FOREST GROVE PLANNING COMMISSION MEETING
COMMUNITY AUDITORIUM, 1915 MAIN STREET
MONDAY MAY 1, 2017-- 7:00 P.M.

Site Plan and Design Review Staff Report and Recommendation

LAND USE REQUEST: Site plan approval and design review of Stonewood Center, a proposed commercial and office complex consisting of four buildings totaling 45,280-square-feet, a restaurant with drive-through, parking and landscaping

FILE NUMBER: 311-16-000197-PLNG

DRIVEWAY AUTOMOBILE STACKING PLAN

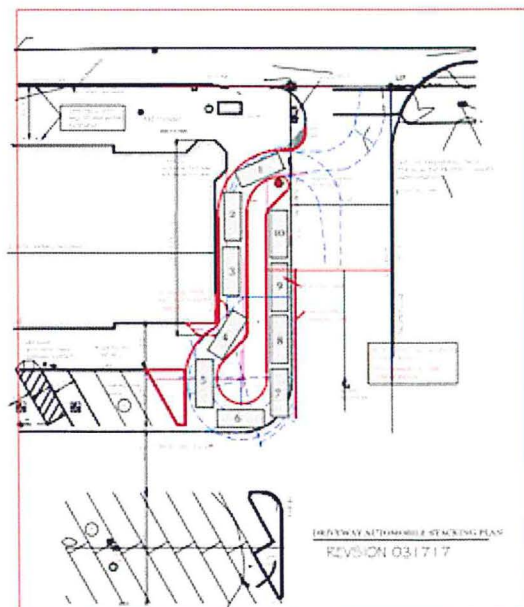
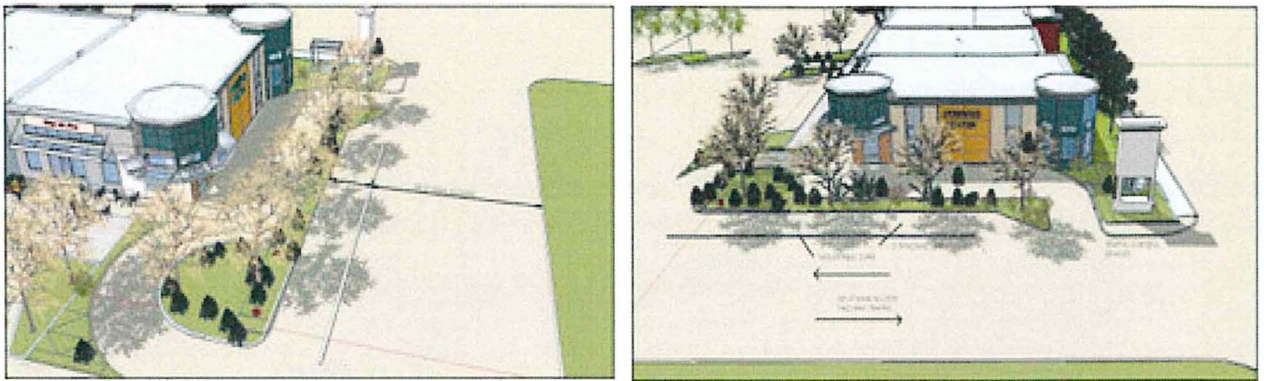
The traffic conflicts with this proposal are obvious: vehicles exiting the drive-through will be cross-ways to inbound traffic, and since the exit lane would be located only about one car length from Pacific Avenue, back-ups are likely. There would also be an increased probability of collisions between the inbound traffic and traffic exiting the drive-through (T-bone collisions) as well as an increased probability of rear-end collisions if multiple inbound vehicles are backed up into Pacific Avenue until exiting traffic has cleared.

The following are ODOT's comments concerning the drive-through (see Exhibit C *ODOT Review Letter*. Note: the "western" driveway referred to below is the only Pacific Avenue driveway serving this complex. The "eastern" driveway referred to in the ODOT letter and the applicant's TIA is the driveway on the east side of the Forestplace Apartment site):

According to the site plan sent to use by the City on March 22nd, the proposed exit for the drive-through aisle is only about 25 feet from the highway right-turn lane curb line at the western driveway. According to the Traffic Impact Analysis (TIS) queueing analysis, the anticipated queue length in the northbound left-turn lane at that driveway during the AM peak is almost 100 feet, which means drive-through traffic wanting to get back onto the highway during the AM peak would be blocked by the queue in the left-turn lane. The turning templates forwarded to us by the City also indicates that drive-through vehicles turning back into the site would be blocked by the left-turn queue since the left-turn lane will be straddling the centerline of the driveway. It's therefore recommended that the applicant not be allowed to locate their drive-through next to the western driveway drive aisle and that it be located elsewhere on the site (perhaps at the west end of the same building).

LANDSCAPE PLAN

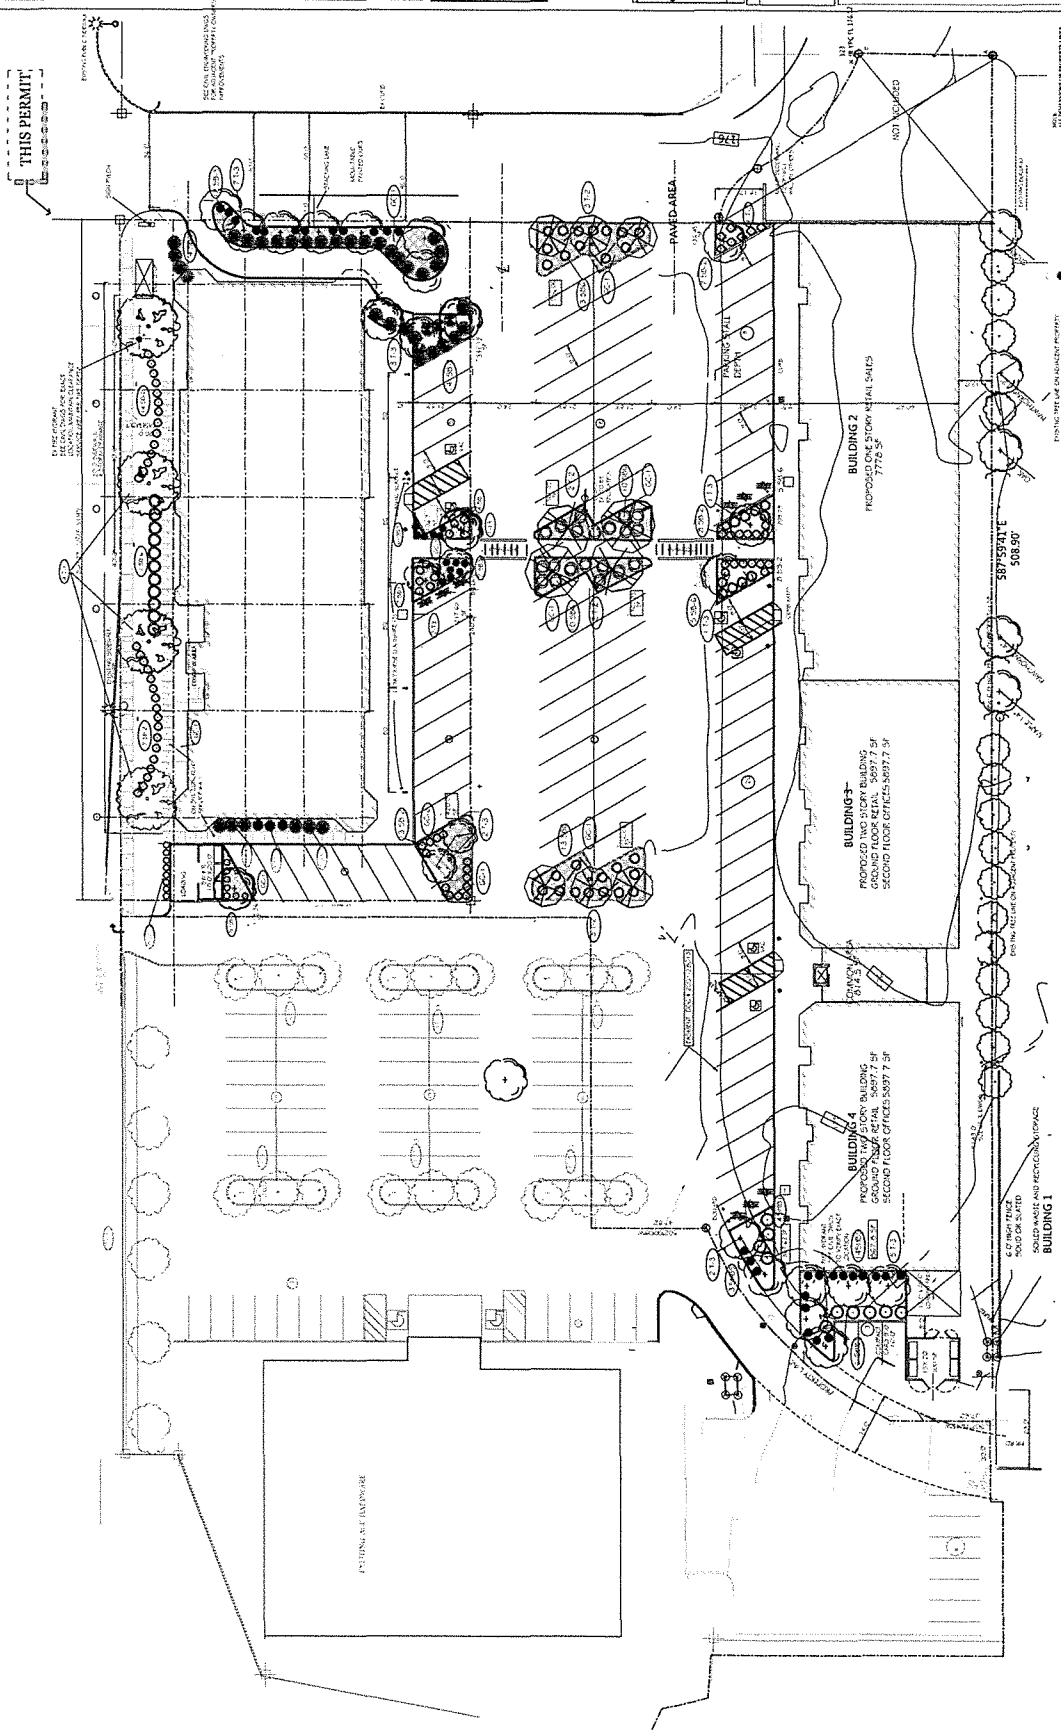
11. Landscaping: DC §10.8.545 requires landscaping and screening of car parks. Proposed landscaping would include paper birch, columnar European hornbeam, and Sargent cherry trees. Shrubs would include a mixture of evergreen and deciduous shrubs, including crimson pygmy barberry, dwarf burning bush, bouquet laurentinus, convexed Japanese holly, and david viburnum. The proposed ground covers of kinnikinnick and blondy wintercreeper are both evergreen. Staff is recommending the following **revisions** to the landscape plan:

- c. Four columnar European hornbeam trees are proposed along Pacific Avenue. Columnar canopy trees are appropriate in order to minimize conflict with the overhead utility lines, but because they have a narrow spread, they would generally be spaced about 20 feet apart. As the project site has 260 feet of street frontage, up to 13 trees could be installed. A lower number of trees would be appropriate due to the existing bus stop, and to provide visibility for both on-building signs and the pylon or monument sign at the Pacific Avenue entrance. Staff recommends a spacing of about 30 feet, which would allow for 9 trees.

- d. To maximize shade in the car park, the Sargent cherry trees shall be replaced where possible with large trees from a City-approved list.
- e. Install additional trees on the south side of Building 1 to provide more shade. Trees shall be selected from a City-approved list. Tree wells shall have a minimum interior dimension of 5 by 5 feet. If installed at grade-level, tree grates shall also be required. If curbed, short fencing (not more than 18 inches tall) shall be installed to prevent pedestrian encroachment and soil compaction.

- f. Install additional trees on the north side of Buildings 2-4 to provide more shade., Trees shall be selected from a City-approved list. Tree wells shall have a minimum interior dimension of 5 by 5 feet. If installed at grade-level, tree grates shall also be required. If curbed, short fencing (not more than 18 inches tall) shall be installed to prevent pedestrian encroachment and soil compaction.

- g. The landscape plan shall be revised to incorporate the above revisions, and submitted for review and approval by City staff prior to landscape installation.

DRIVEWAY AUTOMOBILE STACKING PLAN
SCALE 1" = 20.0'

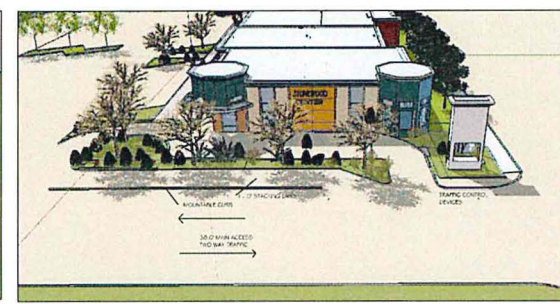
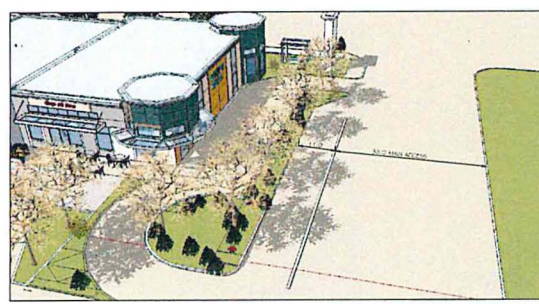
According to the site plan sent to us by the City on March 22nd, the proposed exit for the drive thru aisle is only about 25' from the highway right turn lane curb line at the western driveway. According to the Traffic Impact Analysis (TIA) queuing analysis, the anticipated queue length in the northbound left turn lane at that driveway during the AM peak is almost 100', which means drive thru traffic wanting to get back onto the highway during the AM peak would be blocked by the queue in the left turn lane. The turning templates forwarded to us by the City also indicates that drive thru vehicles turning back into the site would be blocked by the left turn queue since the left turn lane will be straddling the centerline of the driveway. It's therefore recommended that the applicant not be allowed to locate their drive thru next to the western driveway drive aisle and that it be located elsewhere on the site (perhaps at the west end of the same building).

SOUTH ELEVATION A
SCALE 1/8" = 1'-0"

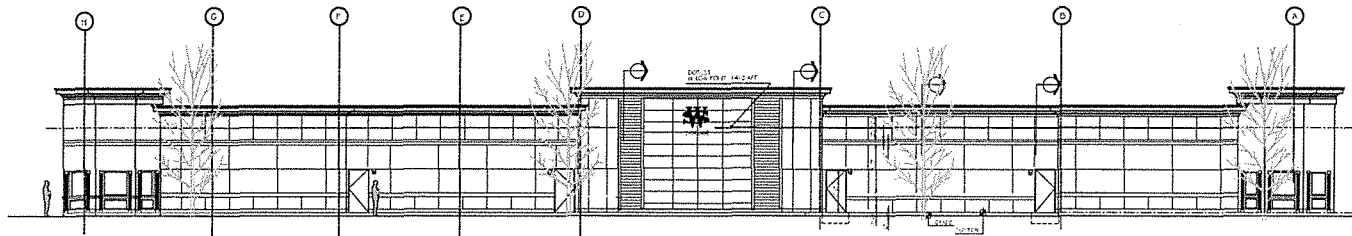
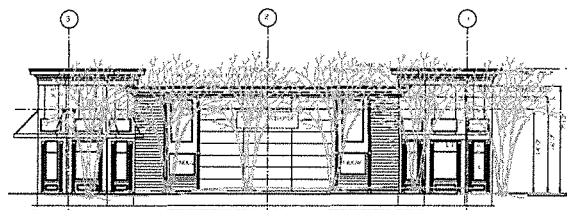
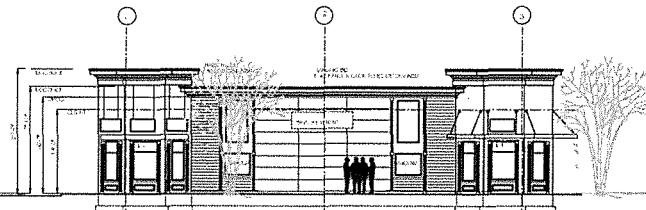
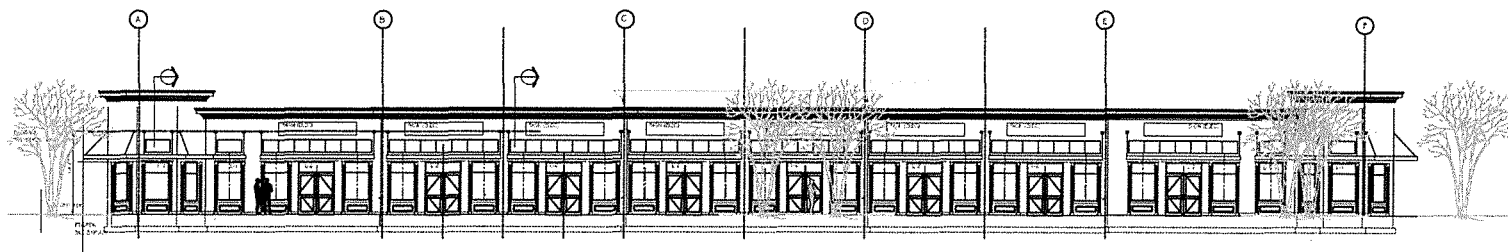
1 is 210 feet long and is adjacent to Pacific Avenue. There are no building entrances proposed that would face the street. The purpose of this standard is to provide convenient pedestrian access from the public sidewalk to the street. With the **condition** to construct walkway connections at both ends of Building 1 to the building entrances located facing the car park, pedestrian access would be provided, and no other conditions appear necessary, although the Commission could require a wider walkway width, especially for the connection to the bus stop.

Staff believes the Commission has two alternatives to meet the Building Design guideline. One option is to reorient some of the spaces to have glazing face Pacific Avenue. However, as previously noted, the buildings’ orientation is to the interior parking lot, which provides some design benefits to move the parking behind the buildings. Thus, the question is whether the design of the building has adequate façade treatment to provide visual interest, order and clarity.

If the option is to require glazing along Pacific Avenue, the façade could be revised to provide 50% transparency, similar to the building in Cornelius above (it too faces an interior car park where the primary business entries are located). Staff acknowledges that not all tenants would desire windows facing the street and would, as in the above example, install translucent or opaque screening material.

The second option would be to consider further enhancements to the façade facing Pacific Avenue. There are good design elements to the façade as proposed. The building heights vary at three locations. Building articulation is employed to avoid the continuous long wall. Although the landscaping shown in the graphic above is not accurate because there is proposed four columnar trees rather than the six spreading trees shown, there will be street trees, ground cover and shrubs along the Pacific Avenue frontage not shown on the graphic. However, staff believes further enhancements could be added to the façade. In particular, the use of additional varying materials such as brick and additional colors would provide a more varied façade which would provide additional visual interest. Also, the continuation of the awnings proposed on the entry side of the building would provide additional visual relief along this façade. (Note: the Cornelius example shown above does provide awnings although that particular design is not particularly noticeable and gets "washed out".) To implement this approach, an alternative **condition** to require additional façade enhancements facing Pacific Avenue be submitted for review and, as approved by staff, be incorporated in the final building design. Such enhancements, as approved by the Community Development Director, shall be the use of brick and other alternative materials, use of additional colors and the continuation of the awnings proposed for the opposite side of the building of the building.

11. Provide at least 25% transparency of Building 1's Pacific Avenue façade end unit tenant spaces, as well as at least 25% of Building 1's east and west facades. The 25% requirement shall be measured below the interior ceiling line.
